SUBMISSIONS REPORT

74 Edinburgh Road,
Marrickville

Prepared for
WOOLWORTHS GROUP LIMITED
27 September 2021

Figure 1 Lodged and Refined Building Footprint – Original/Lodged (left) and Refined (right)

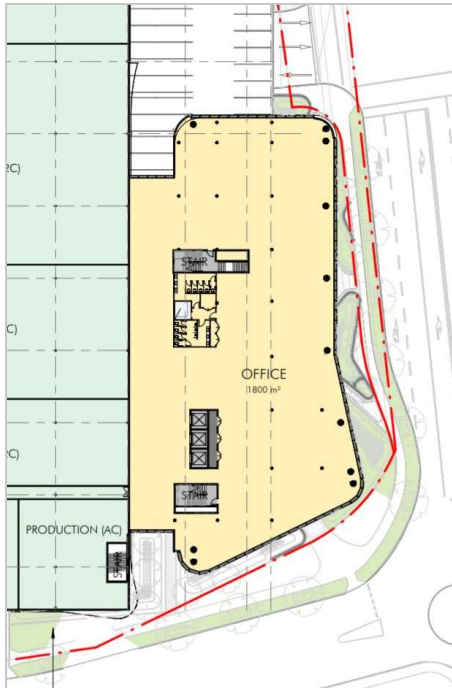
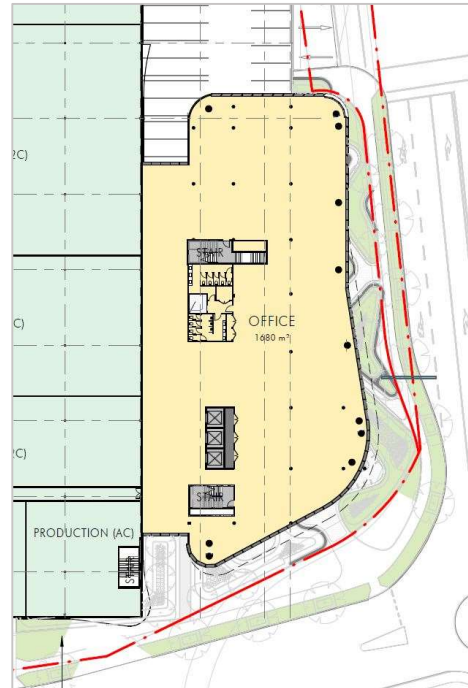
There has been a minor refinement to the building façade alignment since lodgement of the EIS. The northern building façade is now located at least 1m off the stormwater easement and has resulted in a GFA reduction of 600sqm (see Figure 1).

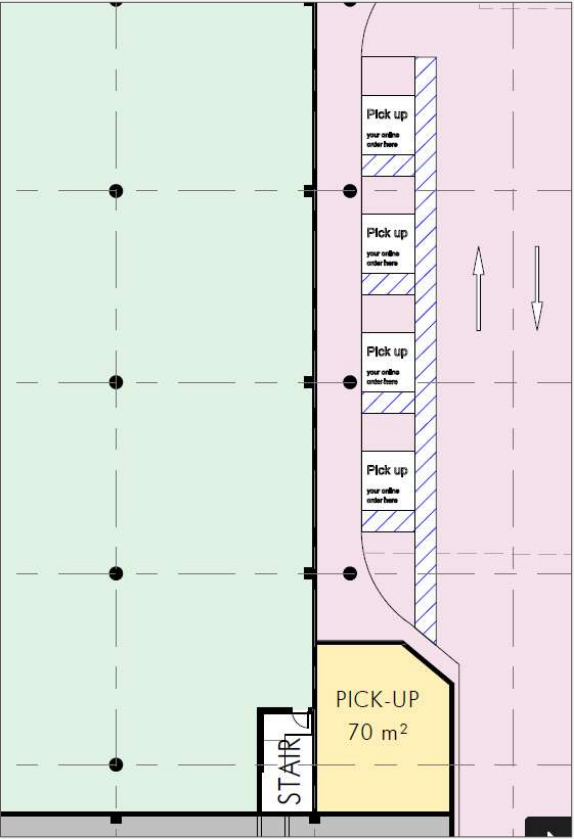
Comment	Response
	<p>'routine entrance or exit point' for customers and heavy vehicles.</p>
<p>The TIA has limited detail regarding the use of point-to-point vehicles to the site, particularly for online orders that may be collected by third parties (other than the customer). The proponent is to clarify how point-to-point vehicles will operate to the site and provide details on how they will be managed.</p>	<p>Woolworths has confirmed the dedicated pick-up facility will predominantly be used by business customers; however, it may also be used by domestic customers. Customers who have pre-ordered and paid for their groceries via the Woolworths online portal can elect to 'Pick-Up' their order at any locations within the Woolworths 'Pick-Up' location network. The customers prepare a shopping list, pay for the grocery items online and nominate a pick-up time. The order is then sorted to their requirements and conveyed to a temperature controlled 'Pick-Up' facility for the customer to collect.</p> <p>As noted in the Traffic Impact Assessment, vehicles operating to and from the site will include:</p> <ul style="list-style-type: none"> ▪ deliveries to customers' homes from online orders (refer to paragraphs 3.2, 3.18 3.20, 3.24 of TIA) ▪ deliveries to replenish the customer fulfilment centre (refer to paragraphs 3.3, 3.18, 3.20 of TIA); ▪ employees (refer to paragraphs 3.3, 3.16, 3.18 of TIA); and ▪ Customers or others picking up online orders directly (paragraphs 3.2, 3.22, 3.23 of TIA). These vehicles will use the pick-up facility located on the ground floor (see plan extract below).

Comment	Response
	 <p>The diagram is a site plan. On the left is a large green rectangular area. To its right is a yellow rectangular area labeled 'PICK-UP 70 m²'. Further right is a pink area containing four rectangular zones, each labeled 'Pick up your online order here'. A staircase is indicated by a line and the word 'STAIRS' at the bottom left of the pink area. Arrows in the pink area indicate traffic flow.</p>
<p>TfNSW has reviewed the internal swept paths for the site and notes that the semi-trailer movement (Sheet 9 in the TIA) is only illustrating the end docking space being utilised. For the other seven loading dock spaces to be utilised, TfNSW believes that the movements may encroach on the car parking spaces.</p> <p>The proponent is to review the swept path of all semi-trailer movements to ensure that the vehicles can operate without impacting the proposed car parking areas.</p>	<p>The western-most dock was included as this is the most constrained in terms of manoeuvring area. Semi-trailers will be able to access all docks.</p>
